## ATTACHMENT 2 - PRCUTS IMPLEMENTATION PLAN OUT OF SEQUENCE COMPLIANCE TABLE

### 67-75 Lords Road, Leichhardt

Image 2 – Taverners Hill Open space and Active transport

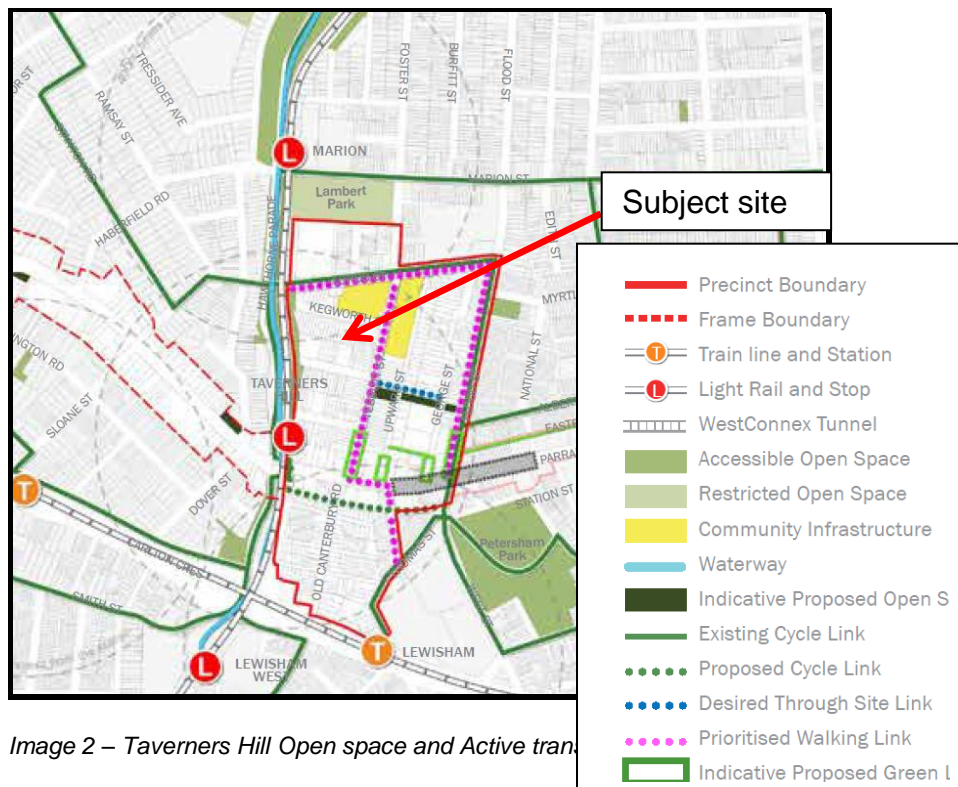
For Lords Road to function as a successful prioritised walking link (refer to image below), public domain improvement works such as footpath widenings, new streetscape plantings to enhance its amenity and streetscape are desirable. The Planning Proposal is inadequate in this regard as it does not contribute to making Lords Road as a street for pedestrians lacking the necessary details and commitments to undertake this.
